PLANNING AND ZONING COMMISSION MINUTES SPECIAL MEETING SEPTEMBER 22, 2015

PLANNING AND ZONING COMMISSION ADOPTED RESOLUTION **September 22, 2015**

PLANNING AND ZONING COMMISSION ADOPTED RESOLUTION September 22, 2015

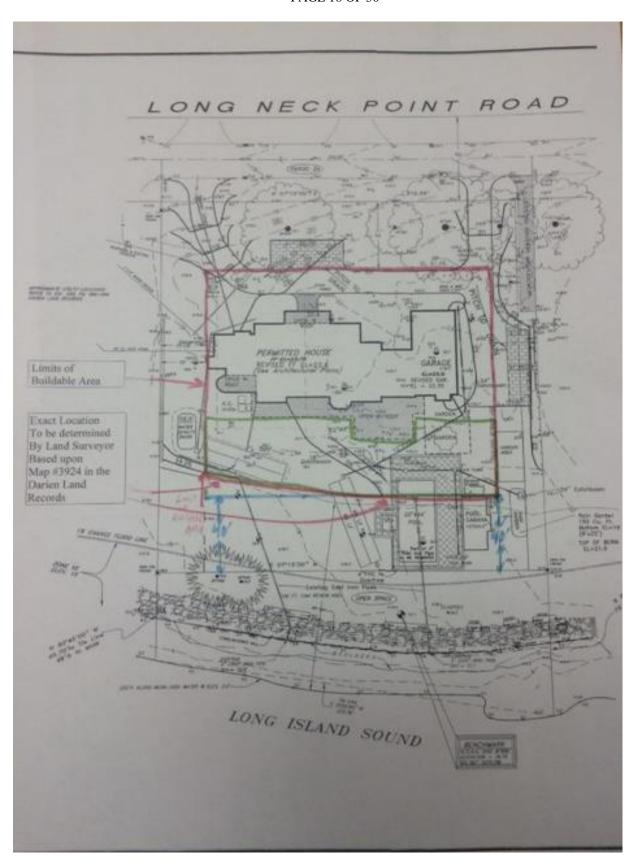
- D. It is acknowledged that the pool, spa, associated pool terrace and/or pool house/cabana may need to be reduced in size, and their location slightly changed in order to comply with the Zoning Regulations and the previous subdivision approval (the two above-mentioned modifications). These elements cannot be larger than originally proposed, since the Commission cannot approve a larger project than originally applied for. All regrading, except for storm water management, shall be located outside of the current 100 foot critical Coastal Area Management (CAM) area. The sketch map on page 9 of this Adopted Resolution reflects the various dimensions and areas noted in Condition A, above. The 40 feet foot rear yard setback is shown in blue. The Limits of Buildable Area shown in the 1975 subdivision map are shown in red. The two lines are nearly coincident, but are not identical. The resulting area behind the residence for the desired construction elements (pool, spa, pool equipment, terrace, and pool house/cabana) is approximately 30' x 160' and outlined in green.

- E. Once revised coordinated plans are prepared, they shall be submitted for the Planning & Zoning Commission file in this matter. The Zoning Enforcement Officer and Planning & Zoning Director shall review the revised plans to determine if they are consistent with this approval. They may consult with the Planning and Zoning Chairman and one other Commission member if there is a question regarding consistency with this approval. If it is found that the revised plans comply with this approval, the property owner may then apply for two separate Zoning and Building Permits--one for the pool, spa, and terrace and one for the pool house/cabana.
